***Basin Electric Power Cooperative  
Laramie River Station  
Best Available Retrofit Technology***

***Control Technology Cost Estimates***

***July 26, 2013***

## ***IPM Cost Algorithms Do Not Calculate Project-Specific Costs***

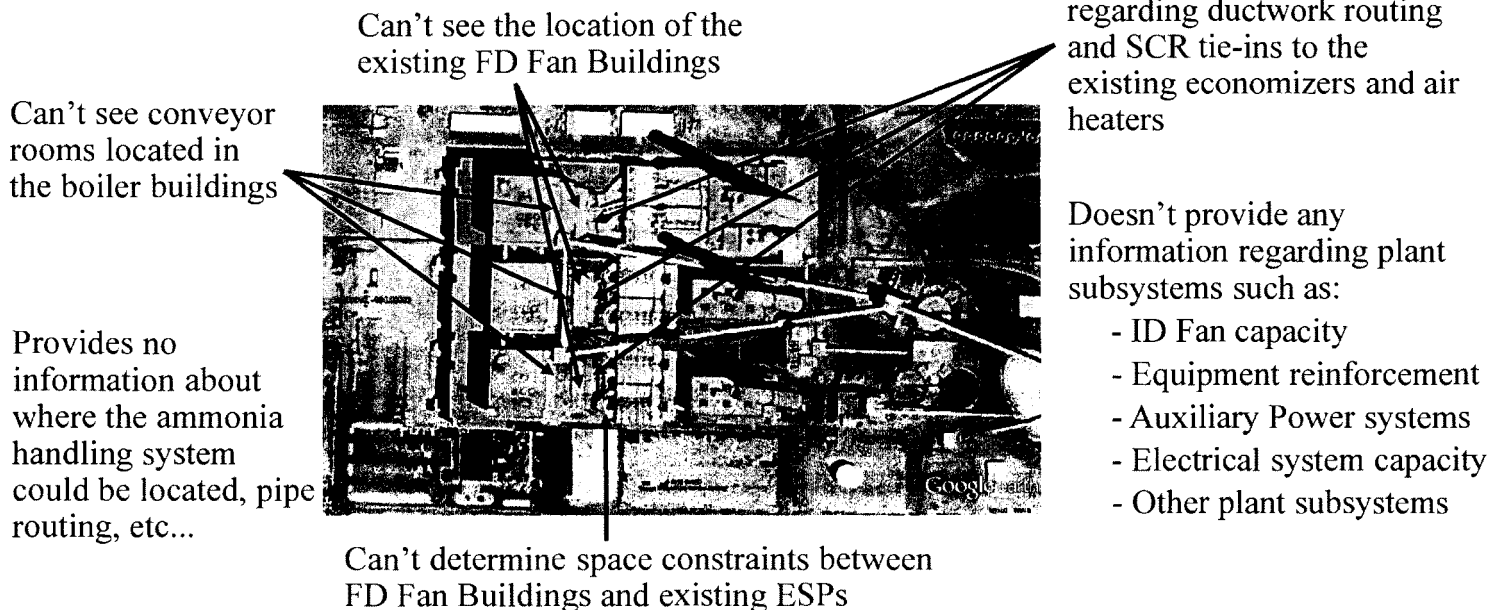
- IPM cost modules were developed by Sargent & Lundy to evaluate system-wide impacts of regulatory programs, and not site-specific costs
- Inputs to the IPM model are limited to unit size, heat rate, coal type, and a subjective retrofit factor
- IPM cost algorithms do not take into consideration site-specific conditions that “affect the cost of a particular BART technology”
